**ADDENDUM
NO. 2**

November 3, 2022

**LIBERTY ELEMENTARY SCHOOL RENOVATIONS
Chesterton, IN 46304**

This Addendum consists of Pages ADD 2-1 through ADD 2-3 and attached Addendum No. 2 from Gibraltar Design dated November 2, 2022 and consisting of 7 pages, Specification Section 08 33 00 - Rolling Doors and Grilles, and 41 Drawings.

UNIT "A" ELECTRICAL FIRST FLOOR DEMOLITION PLAN
SCALE: 1/8" = 1'-0"

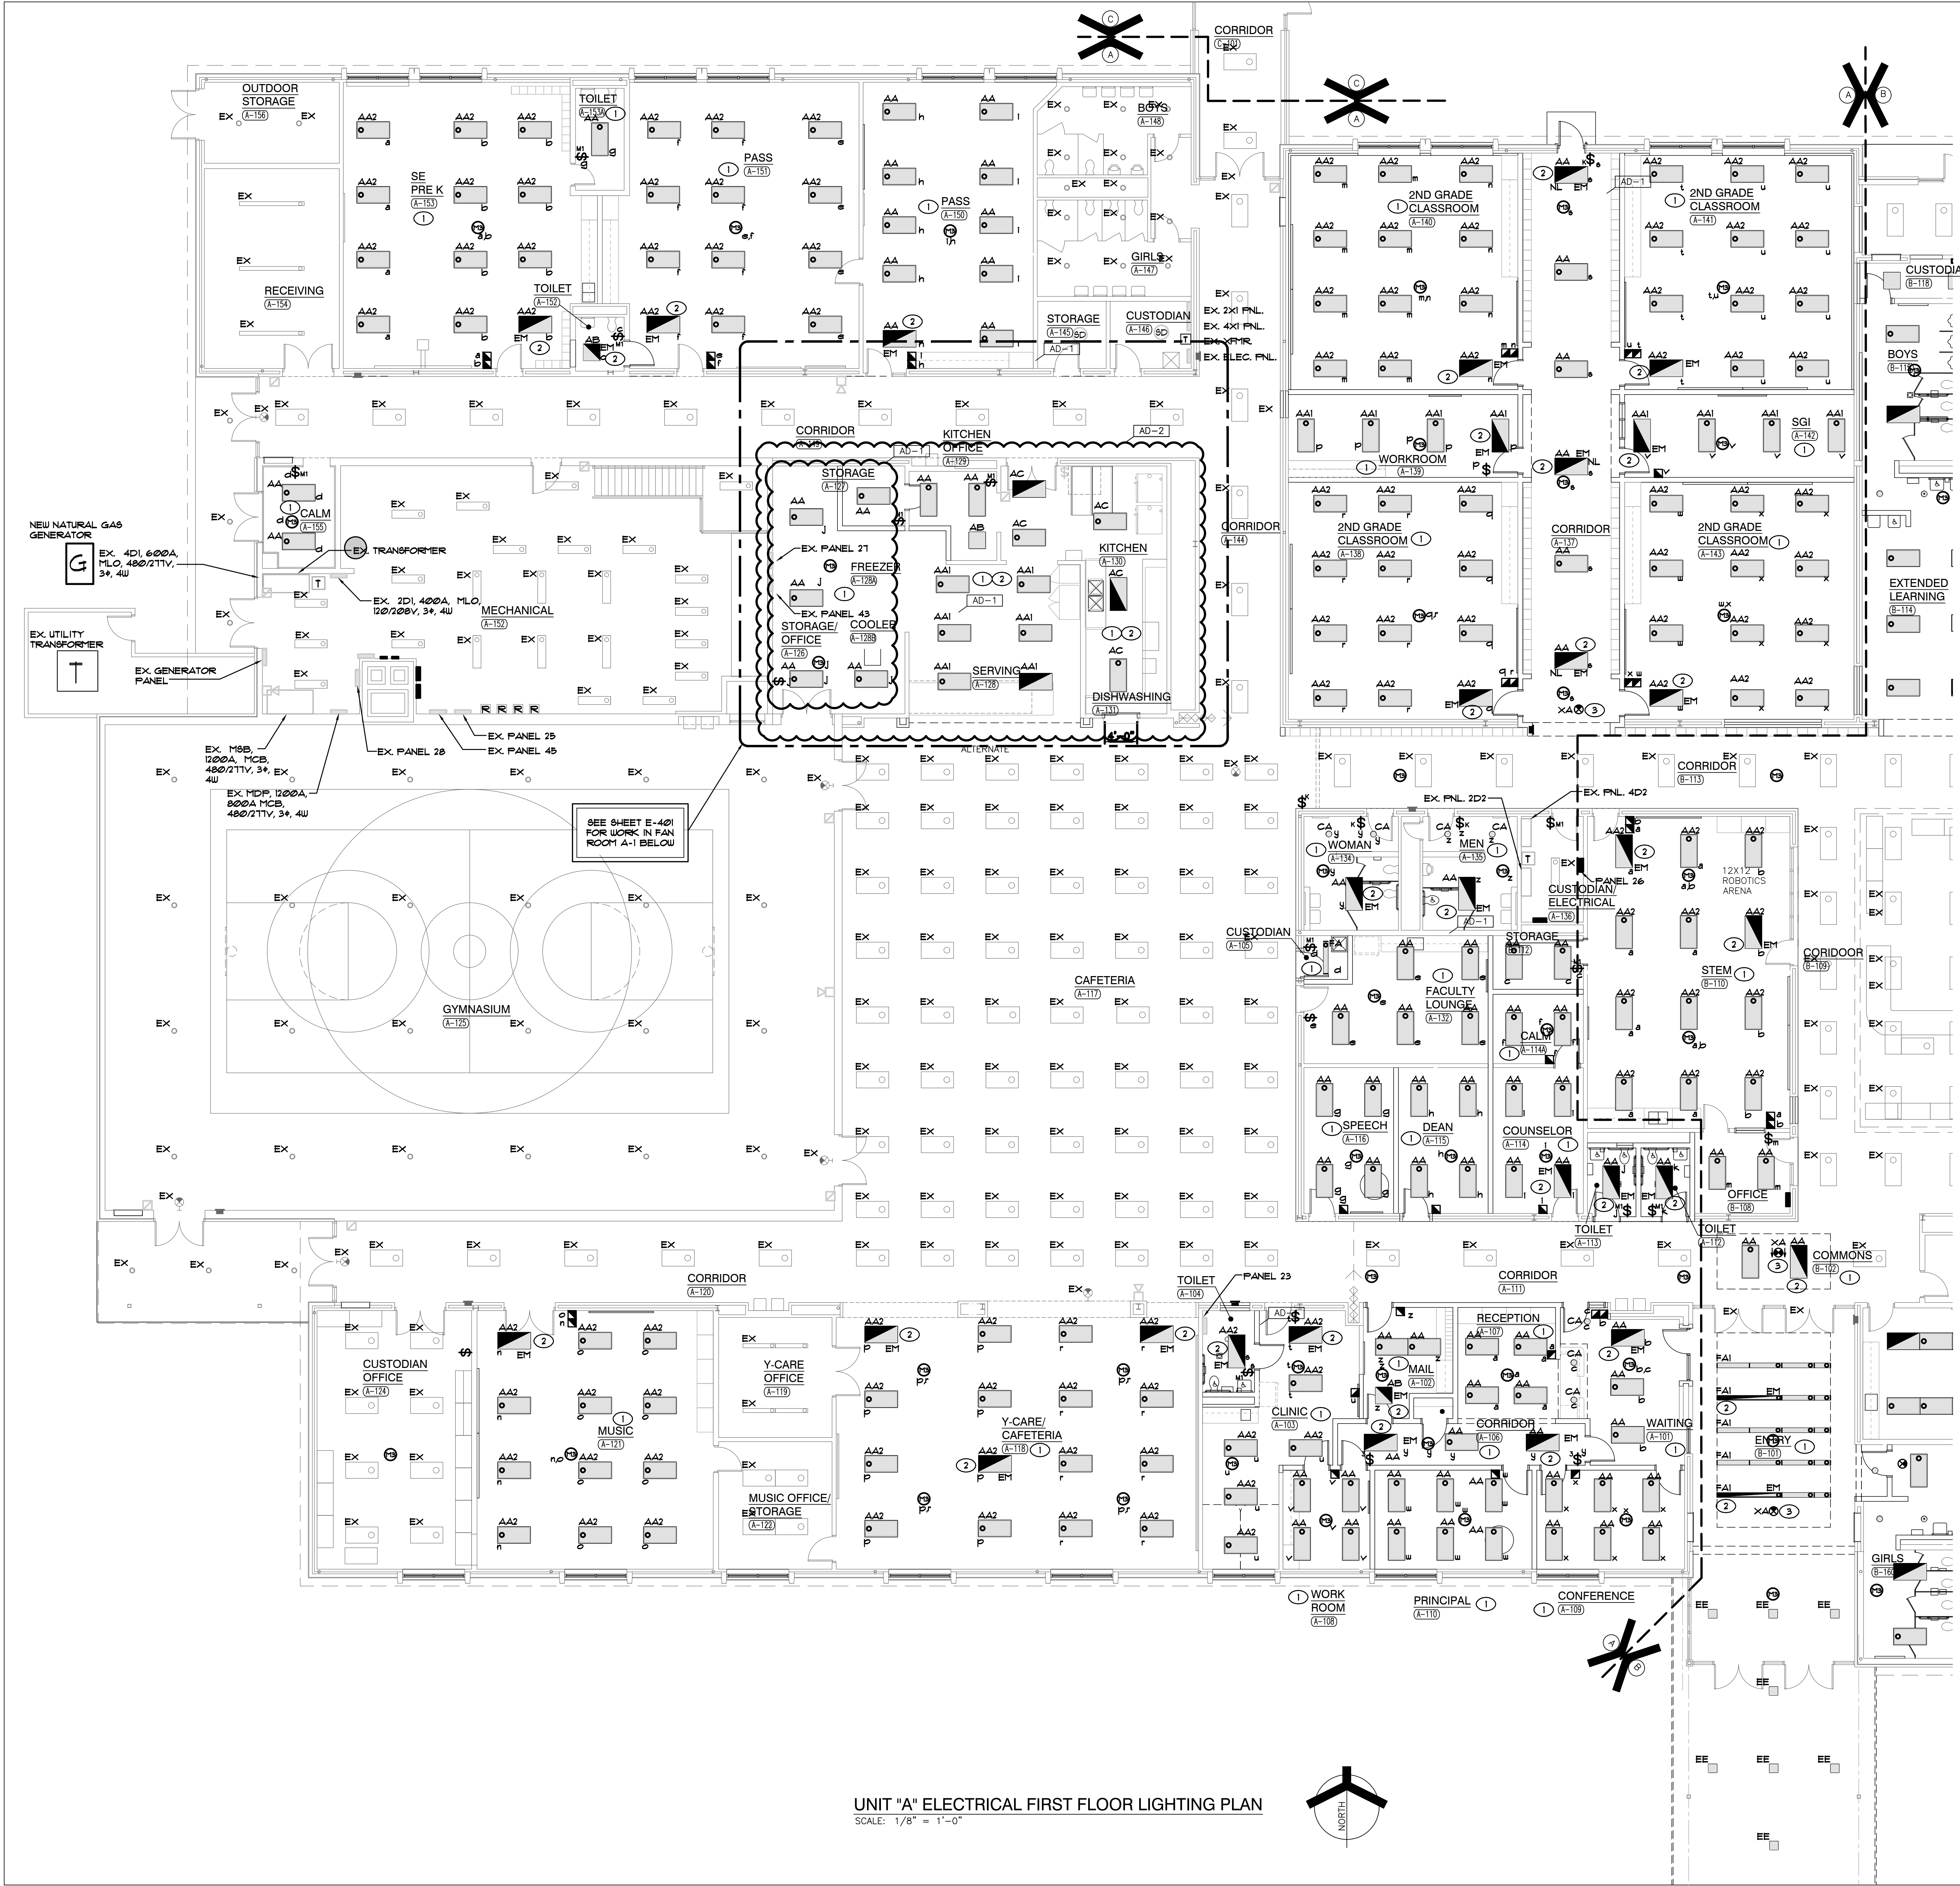
36. Sheet ED101

- A. Refer to revised full size drawing, included in this Addendum, for revised lighting demolition within Kitchen and Gym storage area.

GIBRALTAR DESIGN SHEET
A EL101

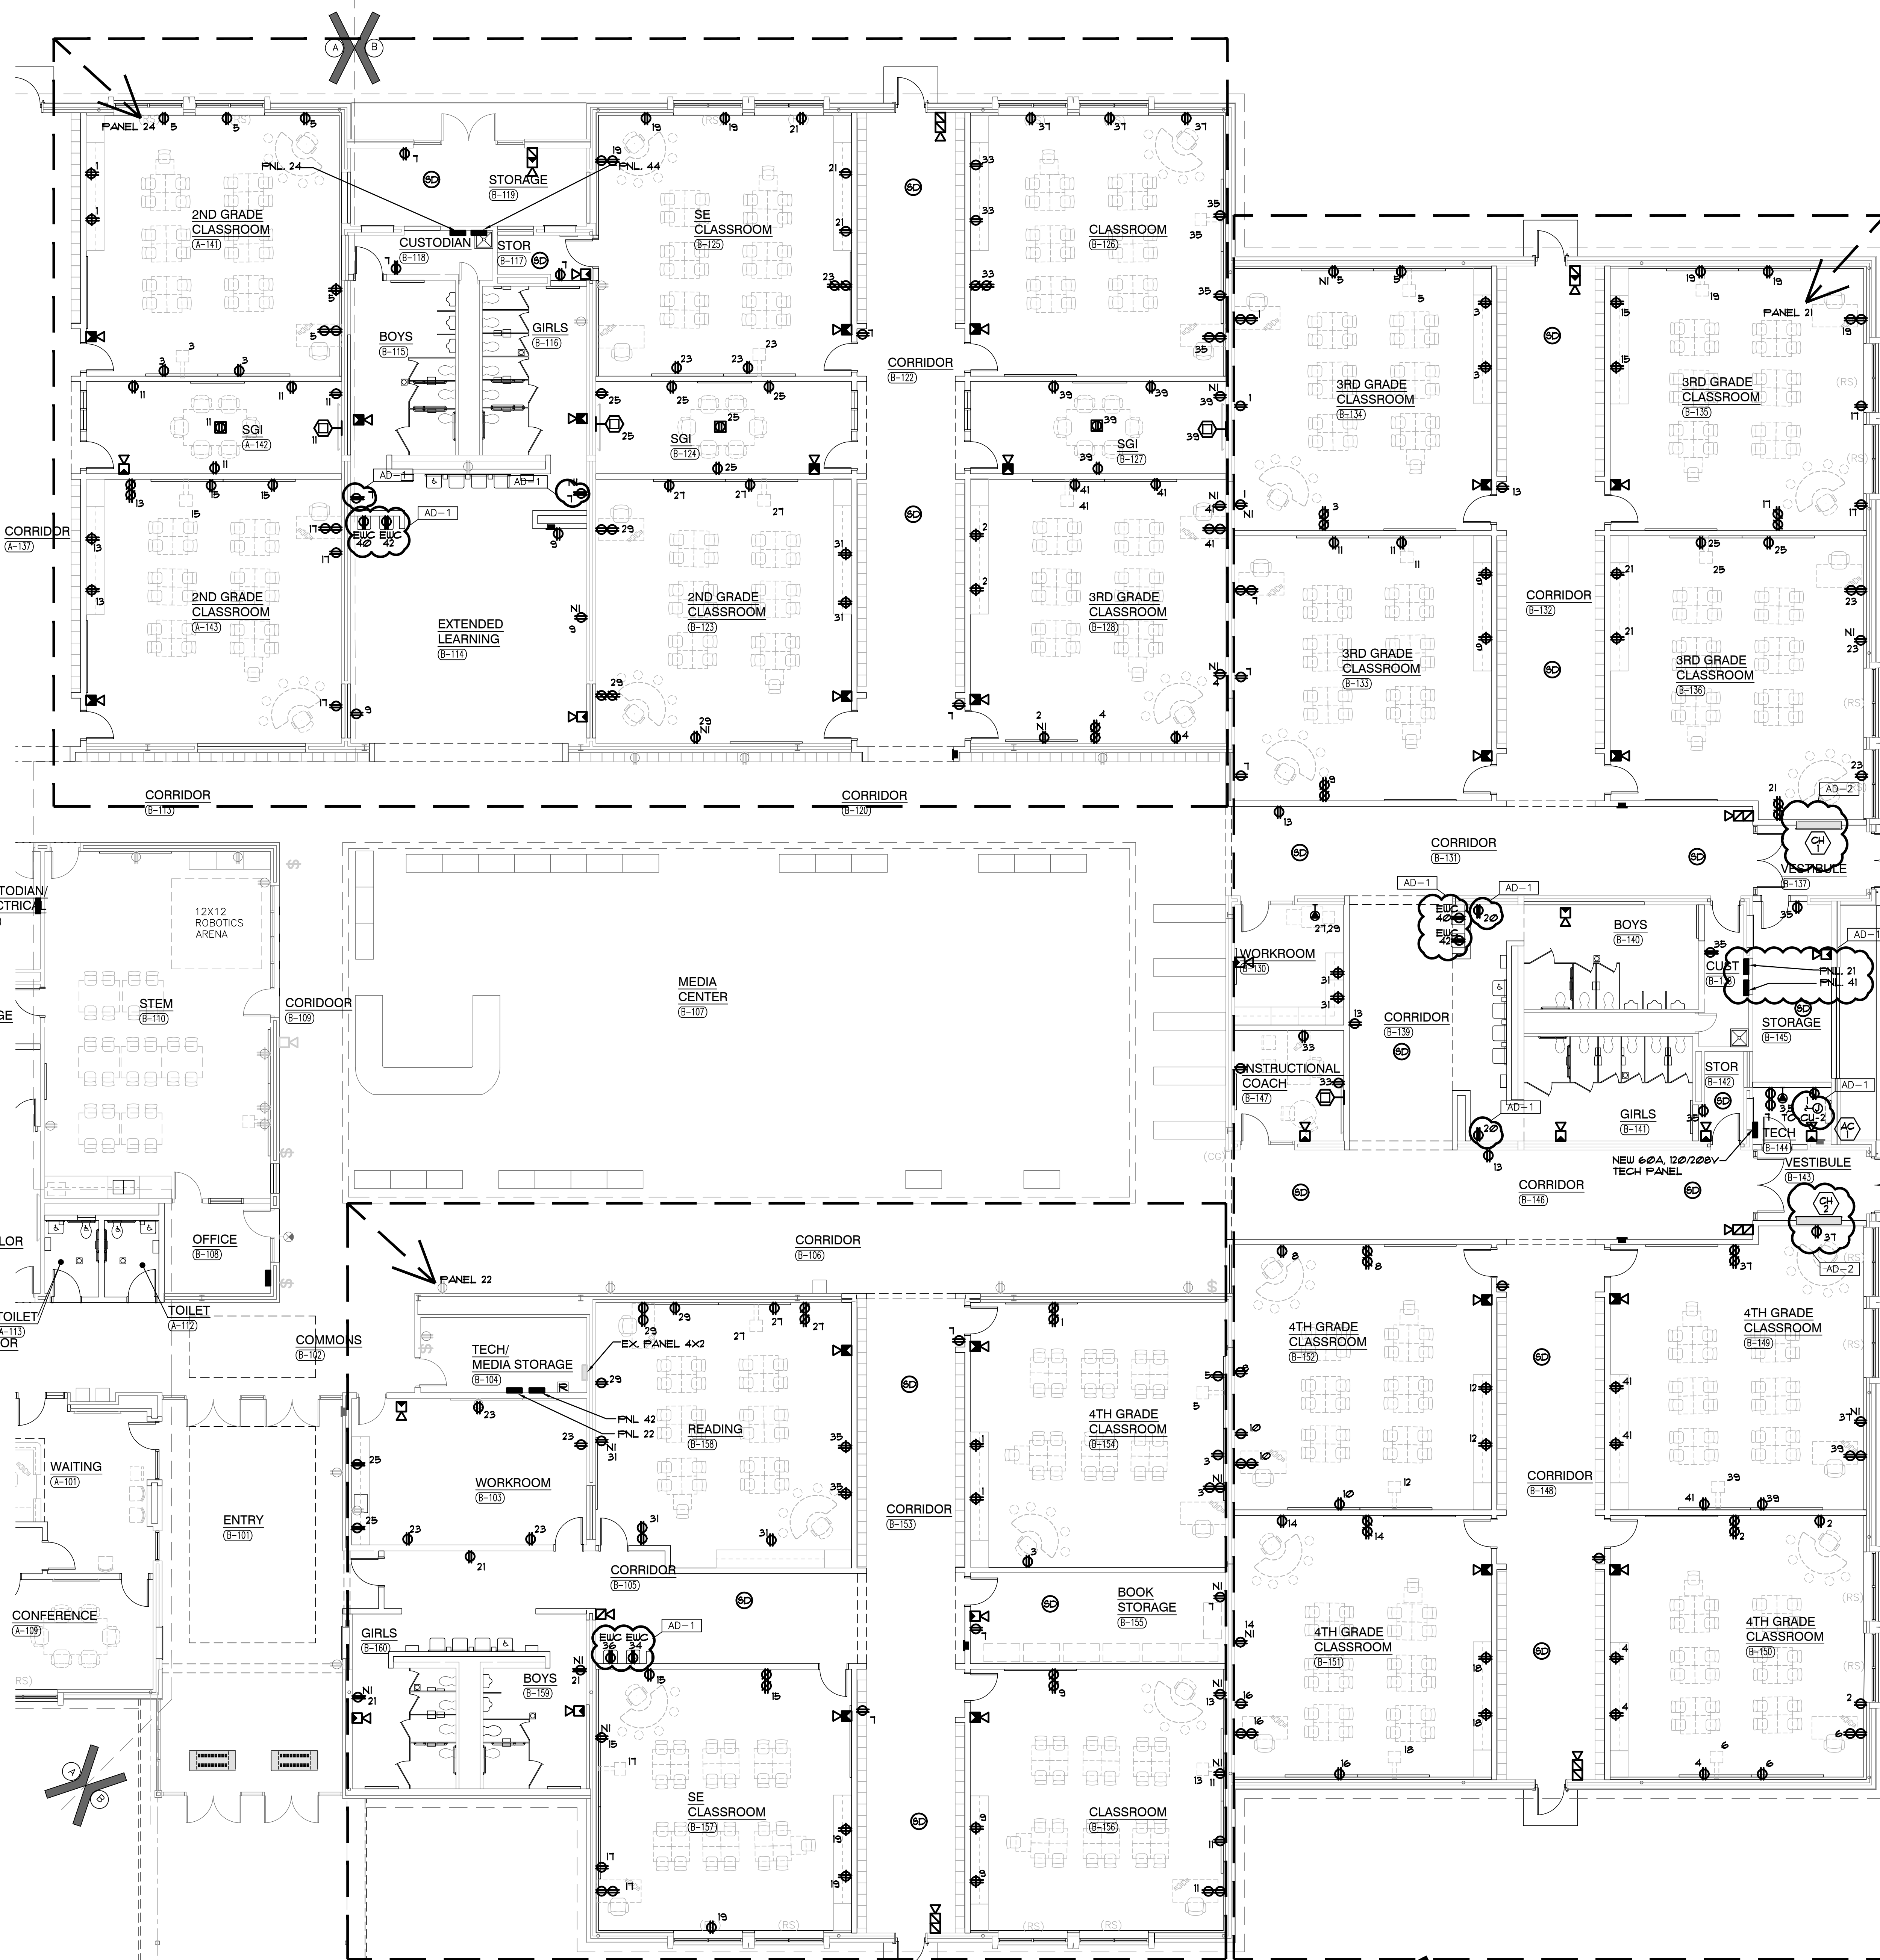
37. Sheet EL101

- A. Refer to revised full size drawing, included in this Addendum, for new lighting added to Kitchen and Gym storage area.
